METROPOLITAN GOVERNMENT OF NASHVILLE AND DAVIDSON COUNTY

STAFF RECOMMENDATION 945 S. Douglas Avenue December 19, 2018

Application: New Construction-Infill (SP Part I)
District: Waverly Belmont Neighborhood Conservation Zoning Overlay
Council District: 17
Map and Parcel Number: 10513028900
Applicant: Nine 12 Architects
Project Lead: Jenny Warren, jenny.warren@nashville.gov

Figure 8: 1914 Sanborn map of the development area.

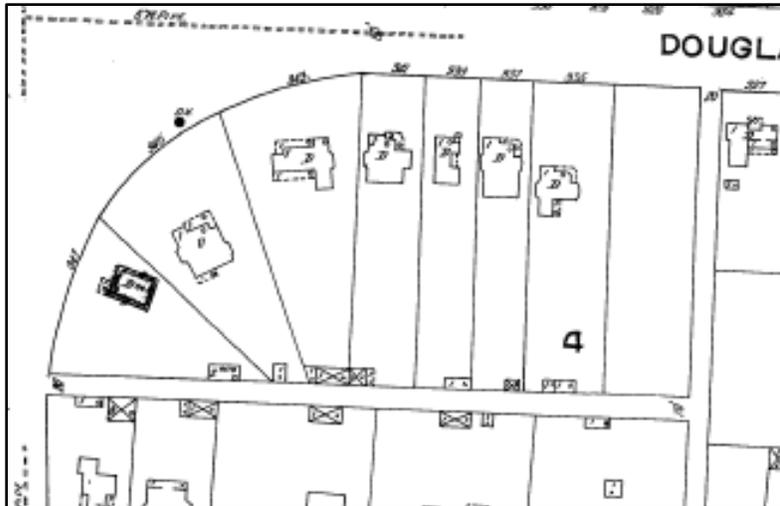
Although the buildings' widths and heights are separated in this report for ease of review, each element of a building cannot be divorced from the other in finding the appropriate massing and scale. In an effort to create a more heterogeneous streetscape, as is typical throughout the historic neighborhood, staff recommends that not all of the heights and widths of the houses facing the street meet whatever maximums are found to be appropriate, and that there be a greater variety of forms. Figure 8 illustrates the variety of forms and house sizes that were located in this area in 1914.

PROPOSED SITE PLAN
 SCALE: 1" = 40'-0"

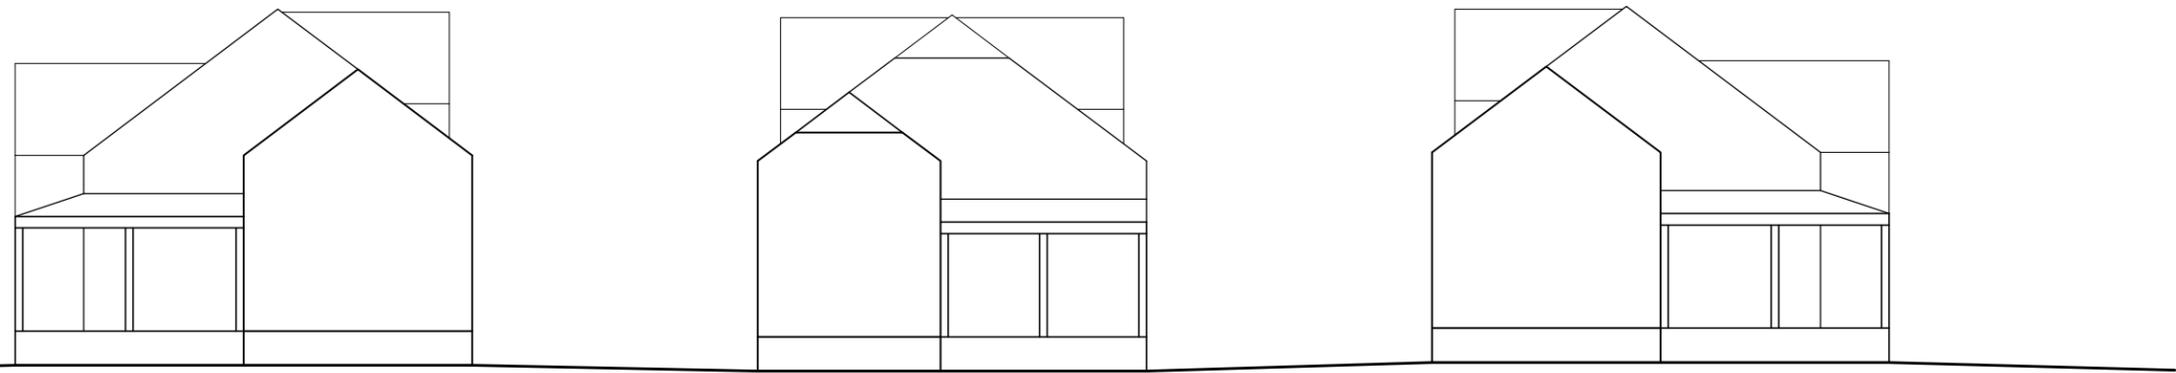
Setback & Rhythm of Spacing: Seven of the nine houses facing the street are proposed to have a twenty foot (20') setback from the front property line (at the interior edge of the existing sidewalk). The two houses furthest east, along S Douglas Avenue (buildings 8 & 9 in Figure 7) will step back, with building 8 set back about thirty-five feet (35') and building 9 set back fifty feet (50'). This step-back is to help ease the transition from the proposed development to the remainder of the houses on the block, which have deep setbacks at approximately sixty feet (60'). At the street, most of the houses will be approximately twenty-five feet (25') apart, though due to the curve of the lot, they will get closer toward the back. Most will maintain a separation of at least ten feet (10'). Staff finds the proposal to meet guidelines III.C.1-3 for orientation and rhythm of spacing.

The interior units will be connected to the street with pedestrian sidewalks. The proposal includes attached garages on all the units. The guidelines state that attached garages are only appropriate for rear units along the alley, however, staff finds that attached garages could be appropriate in this instance, as the interior driveways essentially serve as alleys.

1. Buildings 1 and 8 (Figure 7) be a maximum of two-story forms with a maximum ridge height of thirty-five feet (35') and maximum eave heights of nineteen feet, eight inches (19'8");
2. Buildings 4, 5 and 6 (Figure 7) be a maximum of one-and-a-half stories with a maximum ridge height of thirty-five (35') and a maximum eave height of twelve feet (12');
3. Buildings 2, 3, 7, and 9 be a maximum of one-and-a-half stories with a maximum ridge height of thirty-two (32') and a maximum eave height of twelve feet (12');
4. The front-units have greater variety of forms; and
5. If the SP is approved by the Planning Commission, the applicant will return to the Commission with a second application, or additional applications, including full plans complete with design details review of materials; windows and doors;

TYPE I
 ELEVATIONS

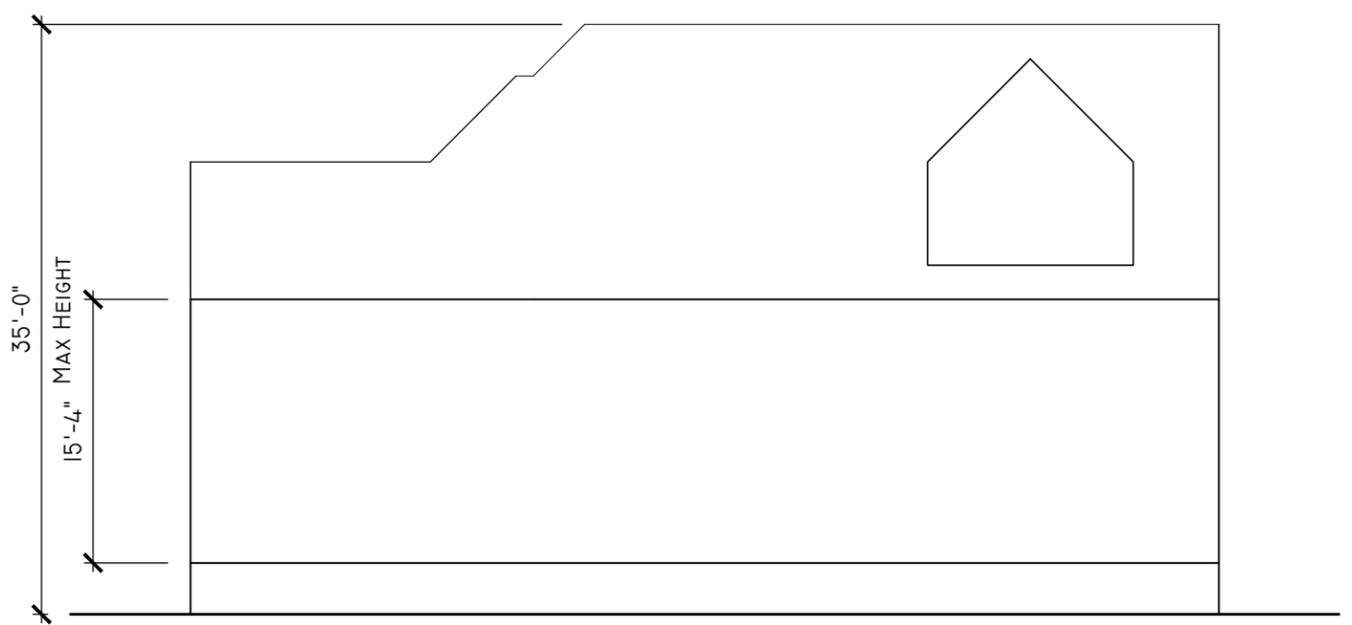
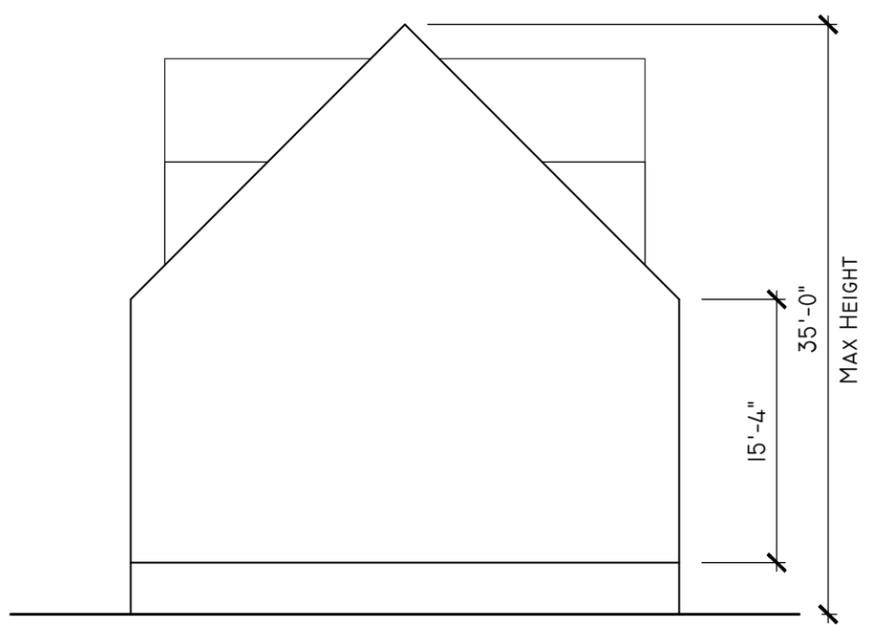
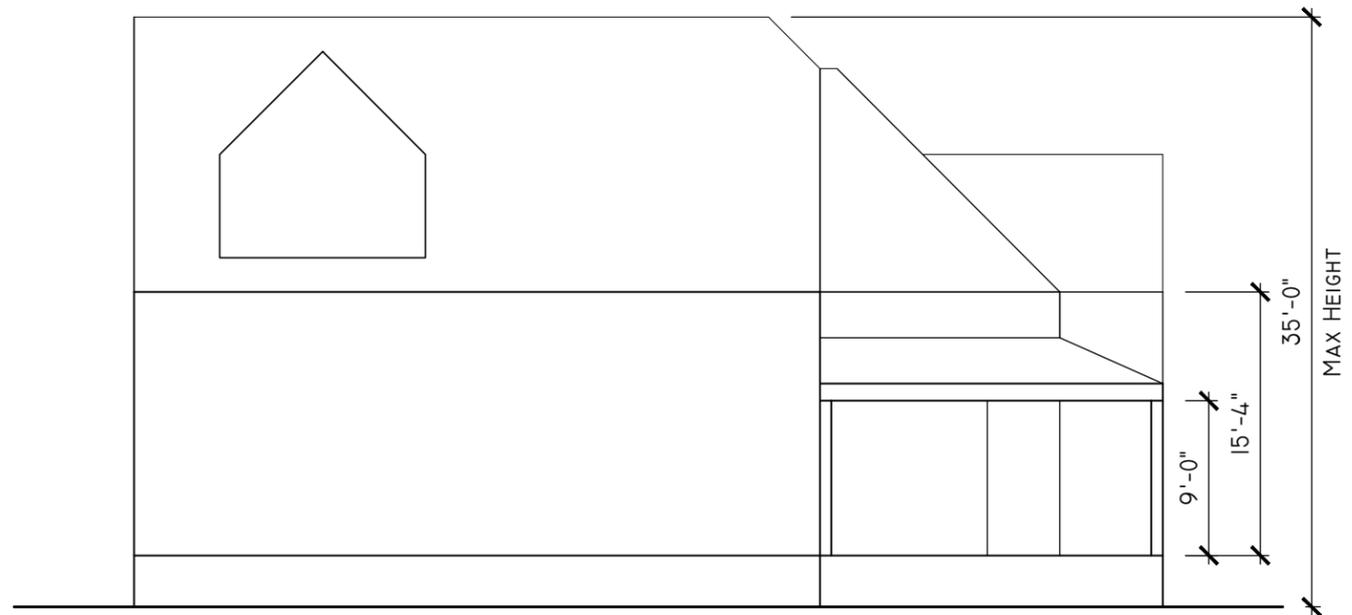
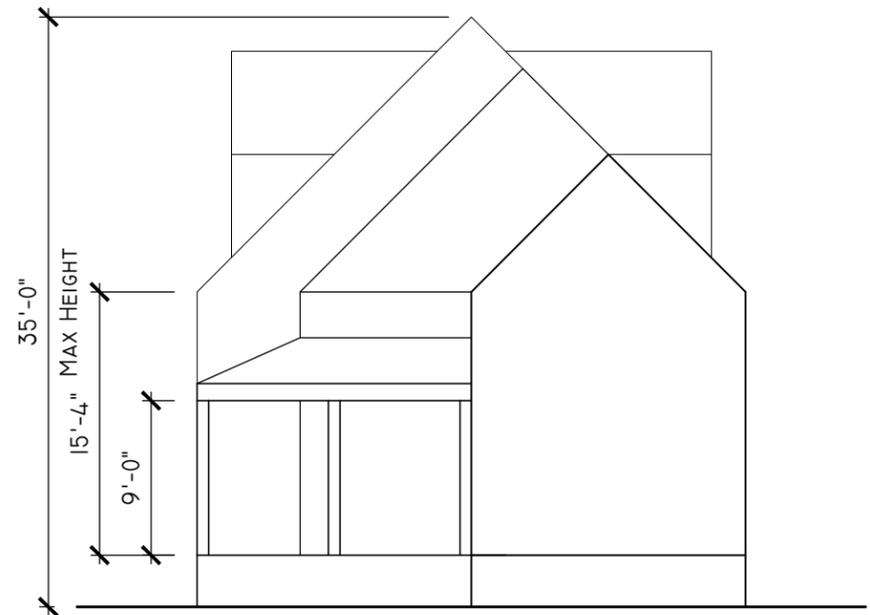
Porch roof and eave heights: The porch eaves are shown at a consistent nine feet (9') from foundation height. With foundation heights that are consistent with the historic context, staff finds that this is an appropriate height for a porch. The roof eaves on the Type 1, 2 and 2A houses (one-and-a-half, street-front) are a maximum of fifteen feet, four inches (15'4") from finished floor and Type 3 (two-story, interior) are approximately nineteen feet, eight inches (19'8").

Staff finds the Type 3 houses to be appropriate as they are interior on the lot, with minimal visibility from the street, and designed to be true two-story homes. Staff finds the eave heights of Types 1, 2 and 2A to be inappropriate as they are taller than is typical on a one-and-a-half story. One-and-a-half story houses have a basic one-story form, with dormers or partial gabled walls that create useable space in a partial second floor. The

one-and-a-half story historic homes in the vicinity have eave heights that average between eleven and twelve feet (11'-12') tall from finished floor. One-and-a-half story buildings approved on S Douglas Avenue, since the establishment of the overlay, have eave heights between approximately nine feet and eleven feet (9' - 11') from finished floor. Staff is concerned that the proposed fifteen foot, four inch (15'4") eave height, combined with the thirty-five foot (35') ridge height - both taller than the historic context- creates an overall height and massing that is too tall for a one-and-a-half story building.

The remainder of the houses along the street should be true one-and-a-half story houses that range between thirty feet and thirty-five feet (30'-35') tall with maximum eave heights of twelve feet (12'). Although thirty-five (35') is significantly taller than the historic context, staff finds the additional height could be appropriate for the street-facing buildings because of the low amount of immediate historic context and is appropriate for the interior lots because of their low visibility from the street. Staff recommends that the maximum height of thirty-five (35') for the street-facing buildings should only be met on three of the remaining street-fronting buildings and all others should be closer to the historic context at between thirty feet and thirty-two feet (30'-32') tall. For example, if buildings 4, 5, and 6 met the maximum height at one-and-a-half stories, they would have the greatest distance from the other buildings that also meet the maximum and from the historic context. This will allow for a greater variety of massings, as seen historically, but still allow for greater height than seen in the immediate context.

TYPE 3
ELEVATIONS

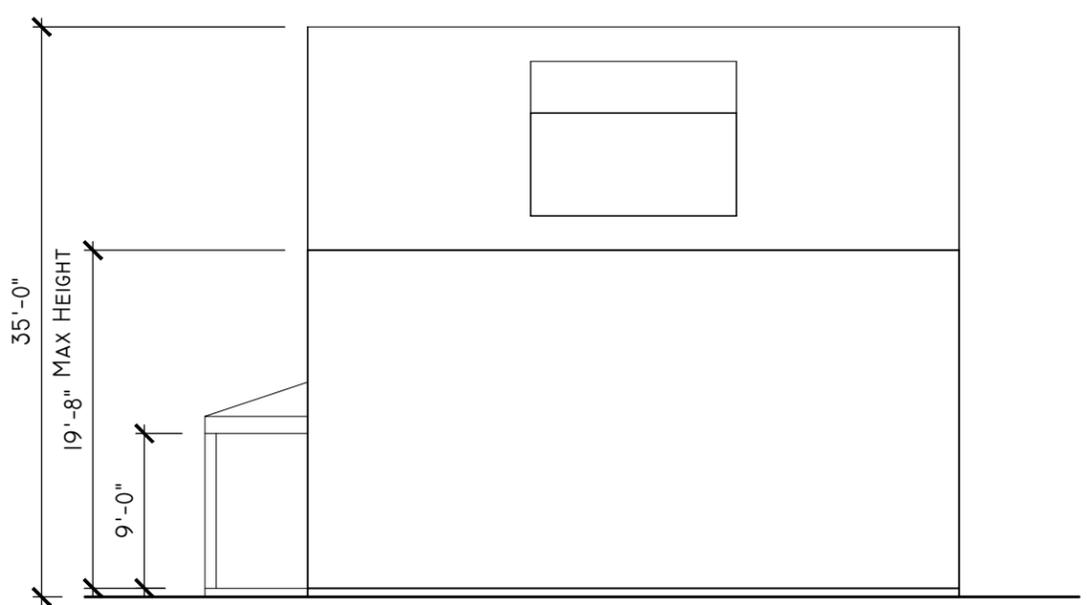
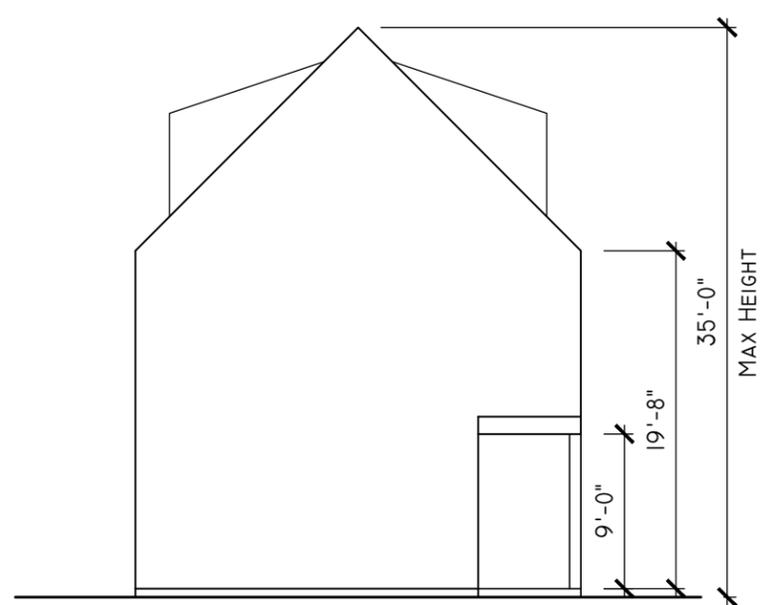
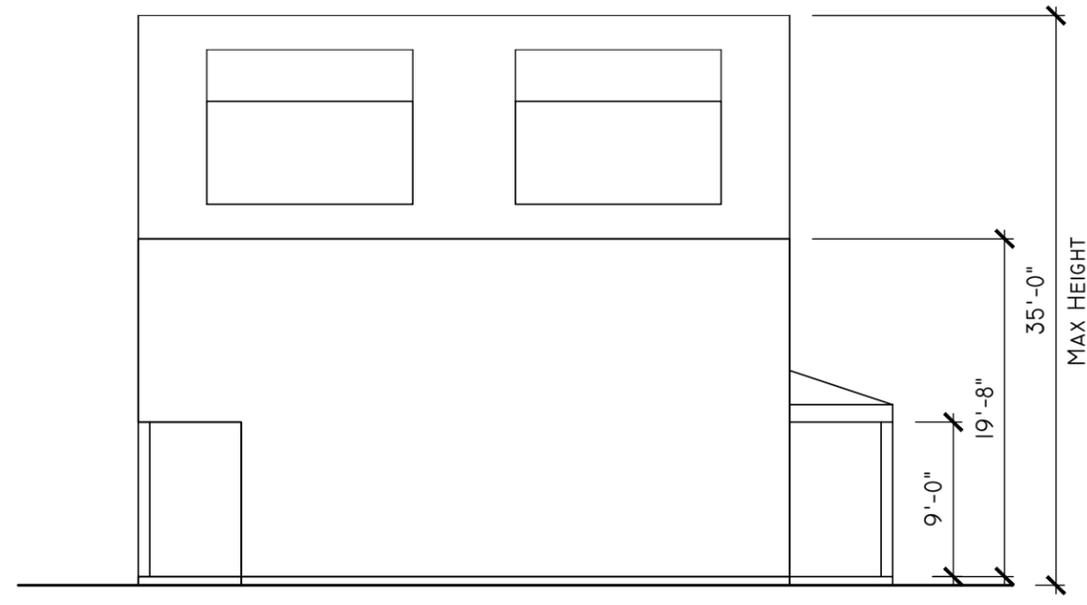
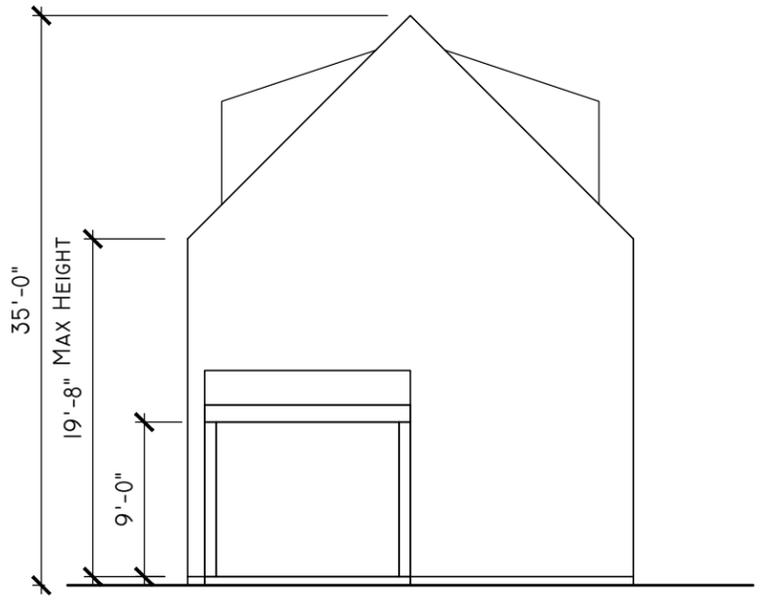
need to be shorter and narrower. At about twenty-five feet (25') wide, the proposed interior house are narrower than the street-facing houses, which are between thirty-three and thirty-nine feet (33'-39') wide. The proposed heights are all a maximum of thirty-five feet (35'), which matches the proposed heights of the buildings in front of them. The building foot prints of the interior houses are about nine hundred and eighty-eight (988) square feet, as opposed to the front houses, which are one thousand, nine hundred and twenty (1,920) square feet and one thousand eight hundred and thirty-six (1,836) square feet. The smaller footprints and widths help to make the interior buildings subordinate to the street-facing buildings.
